16 March 2009
File: EP306

Re: Fort Edmonton Park Administration Building ESR

Figure 1. Fort Edmonton Administration Building REVISED SITE PLAN

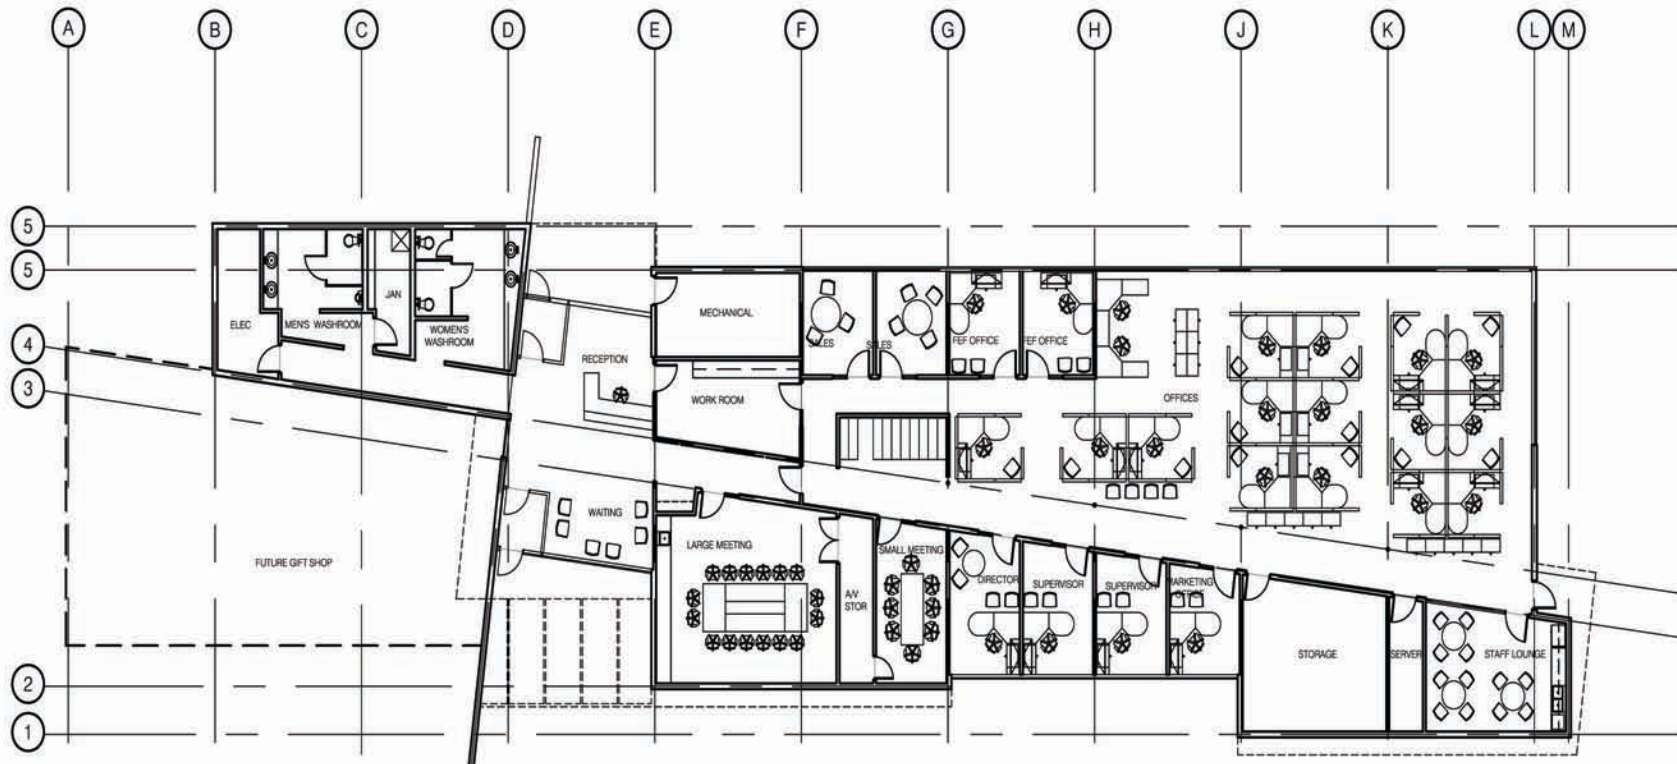
The building components of the revised project are very similar to the original proposal. The exterior design and LEED standards to be incorporated into the facility remain consistent and help minimize short-term and long-term impact of the building on the environment. The project location has shifted slightly, to north, but the site is still off the northeast corner of the train station, within an area of manicured vegetation and gravel access road and parking area. In effect, the only significant changes are the reduction in the size of the building (from 1123 m² to 632 m²) and the elimination of the basement level of the building.

From the standpoint of these minor environmental impacts, the changes in the revised project should reduce the overall magnitude of lost lawn and recreational space. The overall footprint of the building has been reduced and shifted slightly westward from the original site (see attached figures) and in fact, the building now overlaps more of the existing hard landscaping around the train station. The two residual impacts would remain adverse, minor, permanent and predictable, but the overall reduction in loss of these resources will be an improvement over the original design.

**Figure 2. Fort Edmonton
Administration Building
REVISED FLOOR PLAN
MAIN FLOOR**

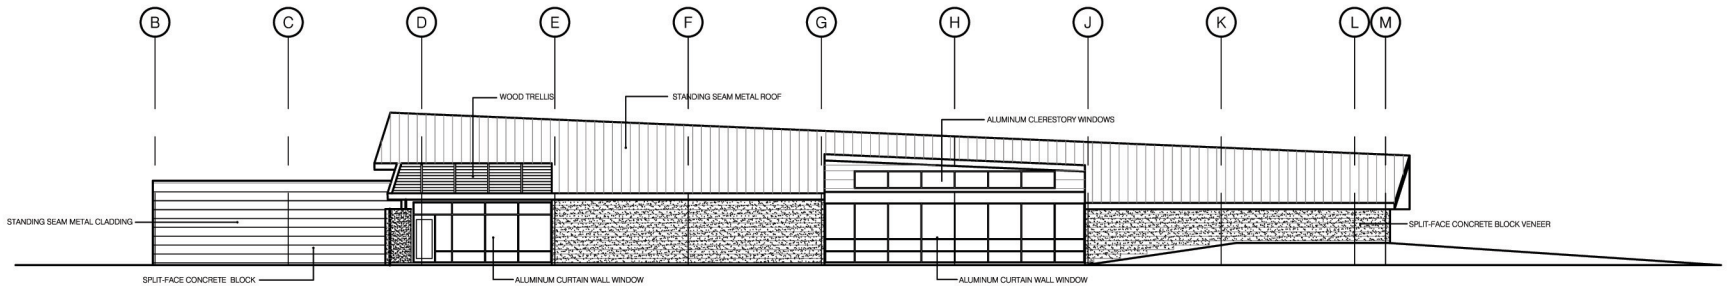
The revised design was developed by Croy D. Yee Architect Ltd. who were retained by City of Edmonton Capital Construction Department. The new building will still be built to LEED Silver level, in accordance with City Policy, but it will be smaller than that originally proposed (632 m²). The building will be constructed on grade (no basement or buried portions to the building) with grade beam and pile foundation and structural steel walls. The roof will meet LEED standards, but will not have any green roof components. Other energy efficiencies of the original proposal have been retained, except for the
